RE: COUNTY OF MENDOCINO, DEPARTMENT OF TRANSPORTATION
LAMBER LANE BRIDGE REPLACEMENT ACROSS ROBINSON CREEK
IN MENDOCINO COUNTY
DOT CONTRACT NO. 230001
PROJECT ID B1302
FEDERAL AID PROJECT NO. BRLO-5910(099)

COUNTY OF MENDOCINO, DEPARTMENT OF TRANSPORTATION
ACKERMAN CREEK BRIDGE REPLACEMENT ON NORTH STATE STREET
CR 104, MILE POST M.P. 0.97
DOT CONTRACT NO. 200093
DOT PROJECT NO. A1101
FEDERAL AID PROJECT NO. BHLS-5910(081)

ADDENDUM NO. 1

CHANNEL RESTORATION No. 4

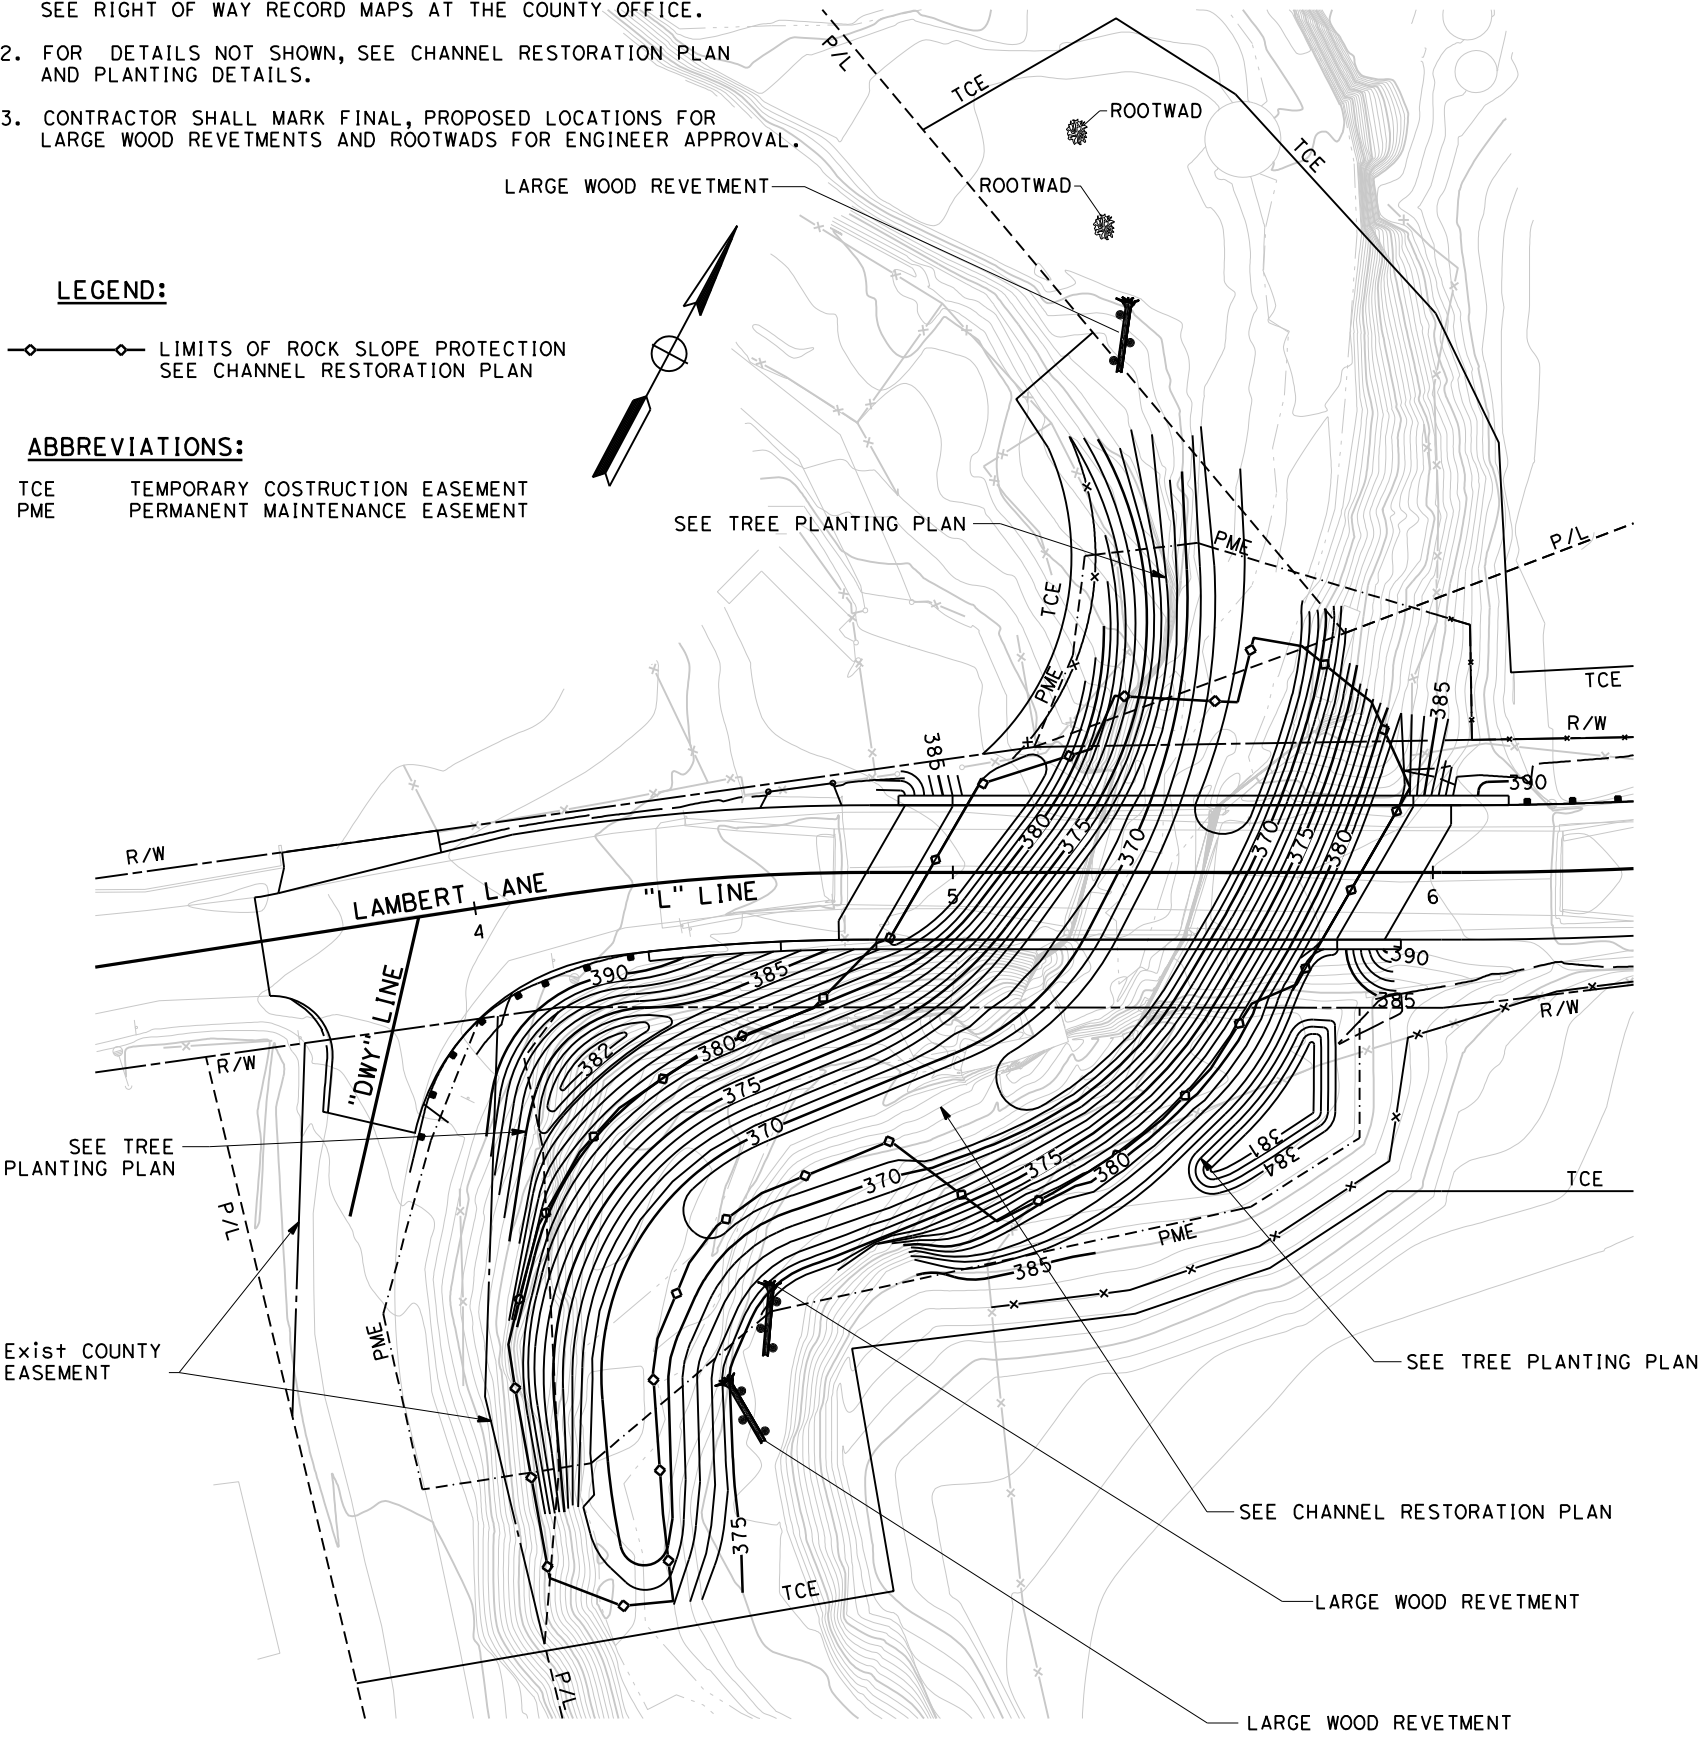
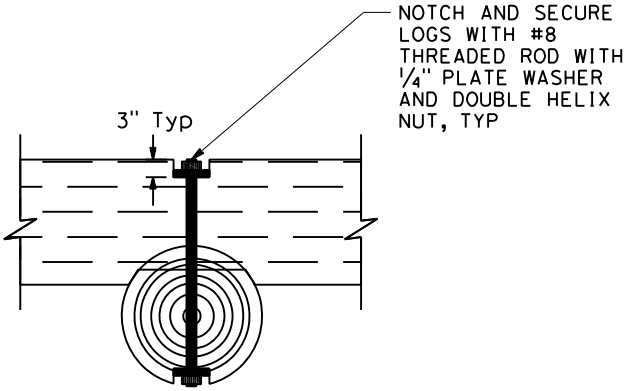
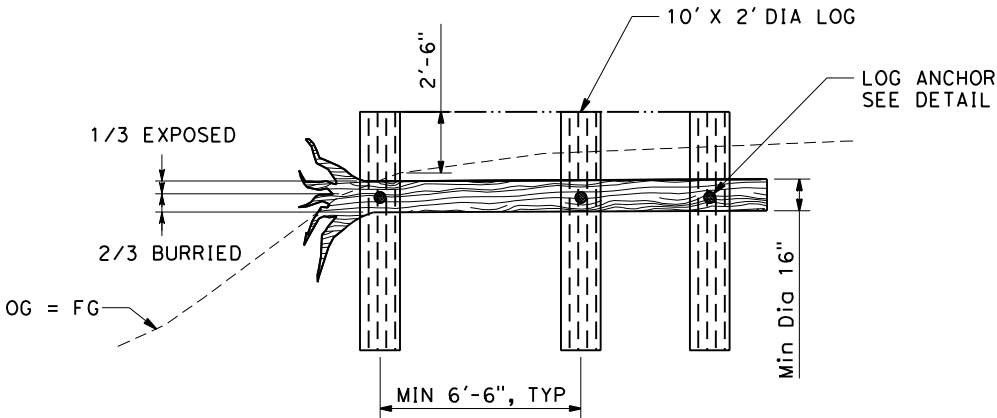
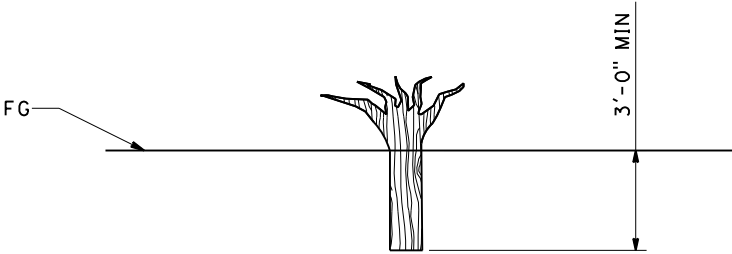
- Plan sheet 13A of 42 (Channel Restoration No. 4): This is a new plan sheet. It shows information related to Large Woody Debris including locations and details.

ADDED PER ADDENDUM No.1
DATED APRIL 11, 2025

ROBINSON CREEK BRIDGE
DECK CONTOURS

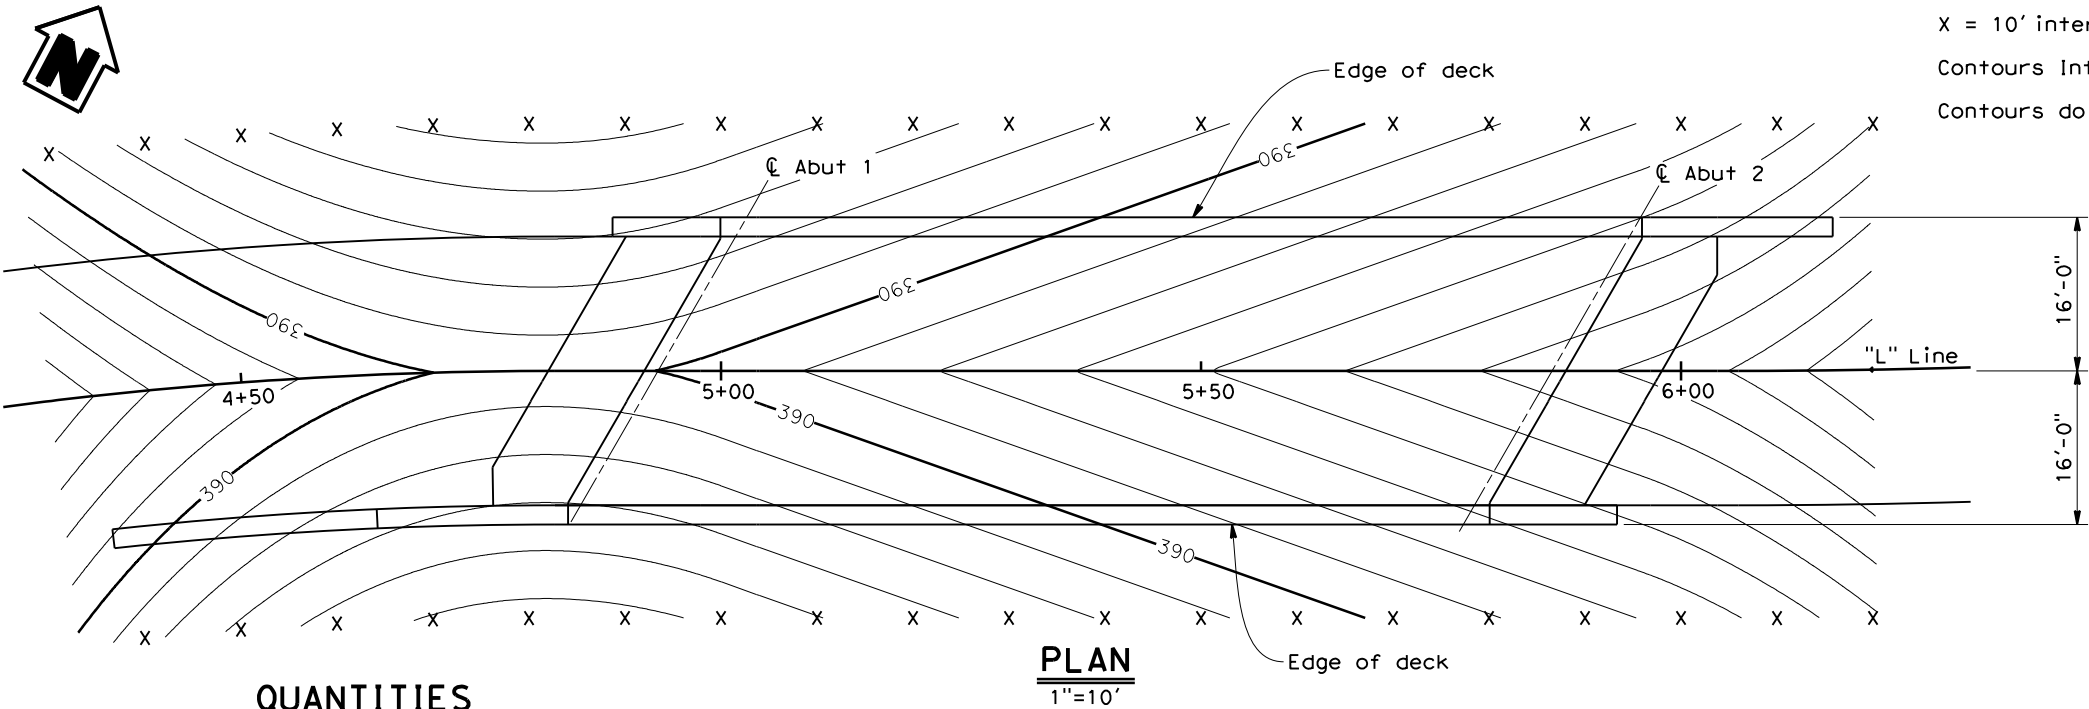
- Plan sheet 28 of 42 (Deck Contours): Revisions were made to the materials specification for steel in the Design Notes.
- Plan sheet 35 of 42 (Girder Layout): Location of the Drip Plate Detail and Limits of Girder end painting were added.
- Plan sheet 37 of 42 (Girder Details No. 2): A detail was added for painting faying surfaces with a Class B coating for the optional bolted splice.
- Plan sheet 39 of 42 (End Frame Details): Drip Plate Detail was added.

1 REVISED PER ADDENDUM No.1
DATED APRIL 11, 2025

STEEL: All structural steel shall conform to AASHTO M270 Grade 50W (ASTM A709 Grade 50W) unless noted otherwise. All bolts shall be ASTM F3125 Grade A325 Type 3 high strength with ASTM A563 Grade C3 heavy hex nuts unless noted otherwise. ASTM F436 Type 3 washers shall be provided under the turned element. Threads to be excluded from shear plane.

ROBINSON CREEK BRIDGE GIRDER LAYOUT

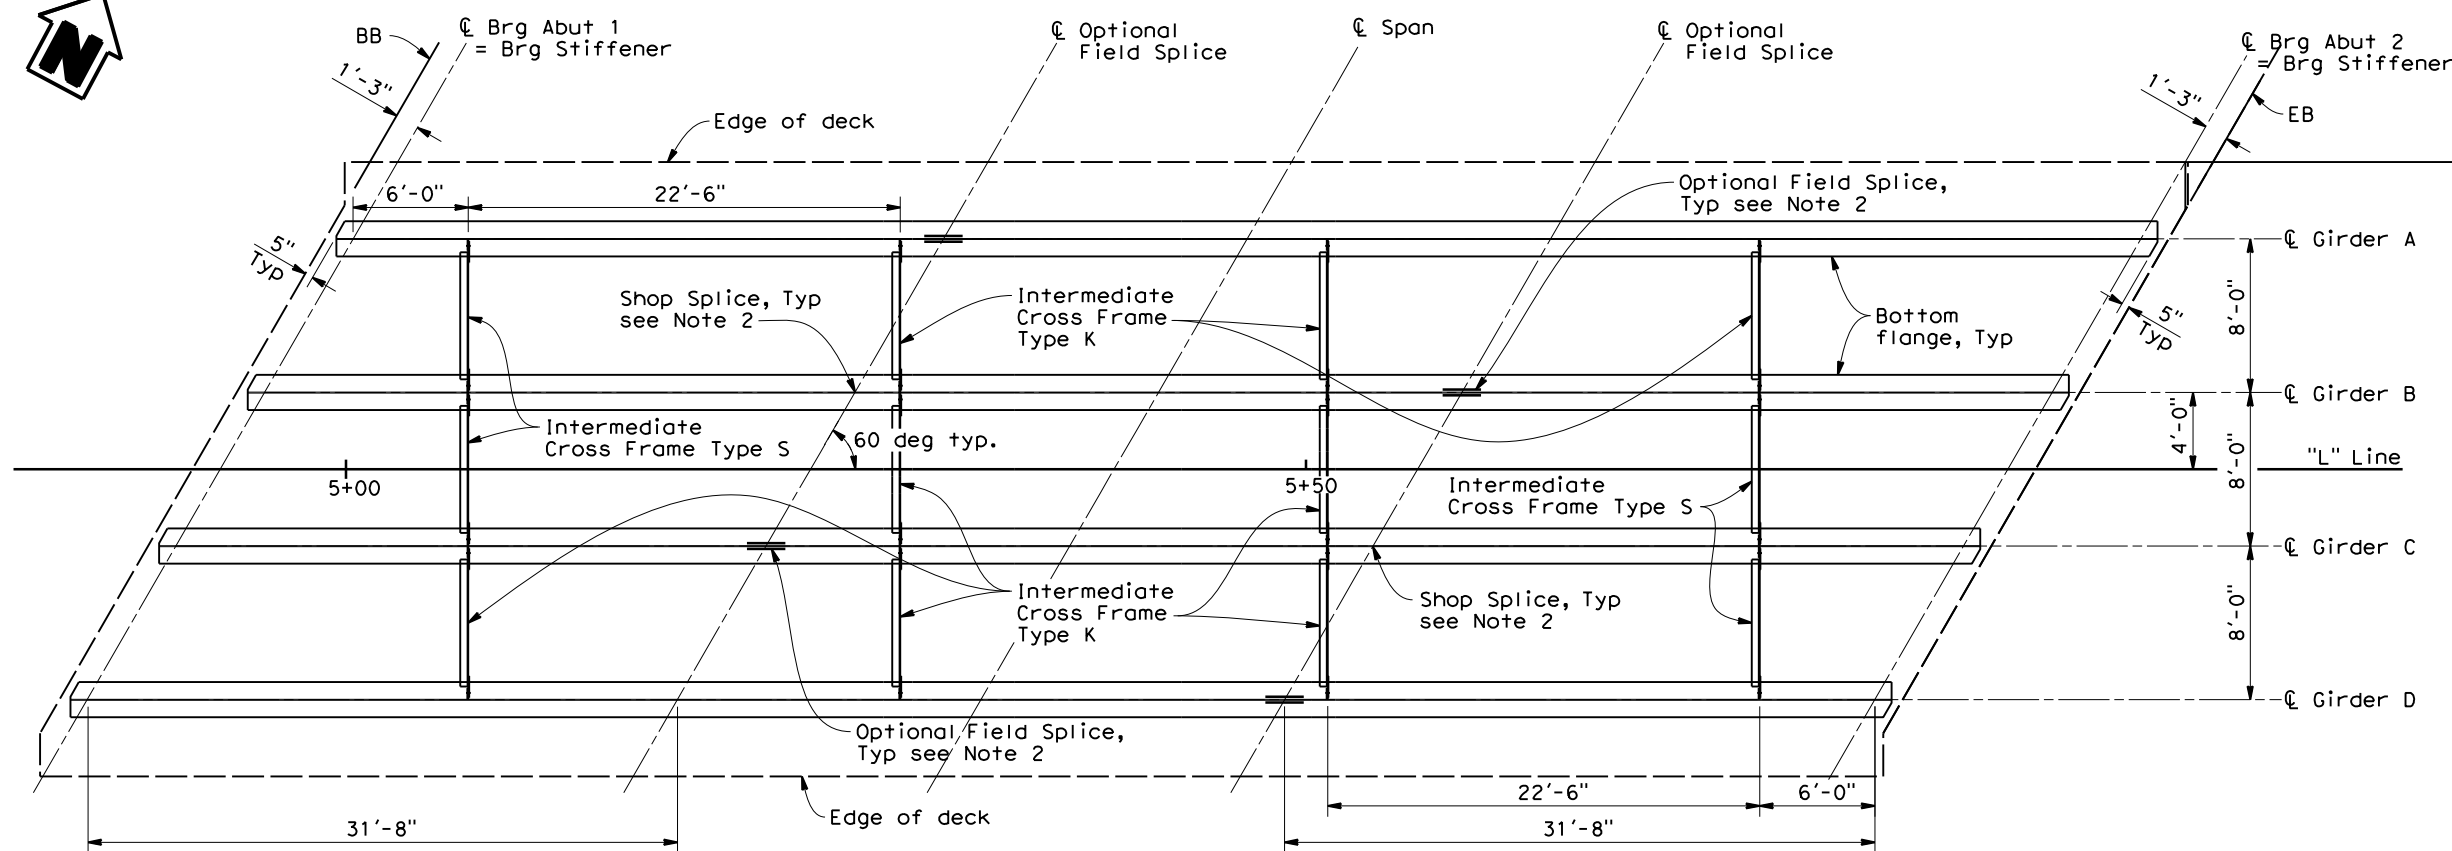
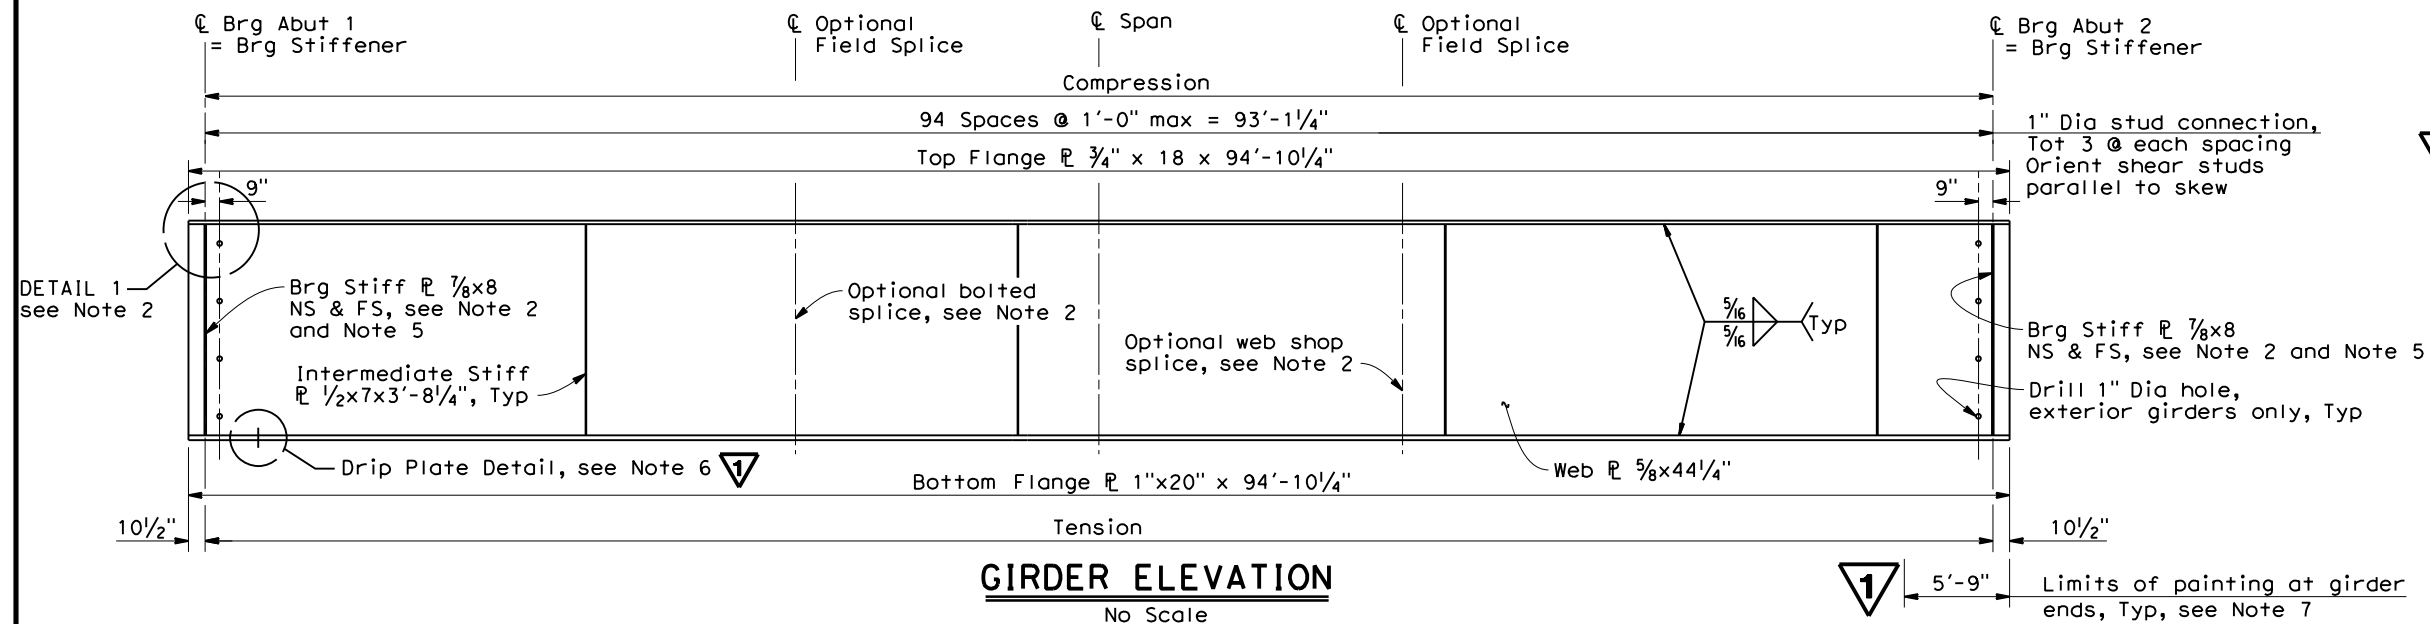
REVISED PER ADDENDUM No. 1, DATED APRIL 11, 2025

1. All girders are parallel to "L" Line.
2. For details not shown, see "Girder Detail No. 1" and "Girder Detail No. 2" sheets.
3. For Intermediate Cross Frame, see "Cross Frame Details" sheet.
4. For end cross frame, see "End Frame Details" sheet.
5. Orient all bearing stiffeners parallel to the skew.
6. For Drip Plate Details, see "End Frame Details" sheet.
7. Paint all girder ends including webs, flanges, and stiffeners.
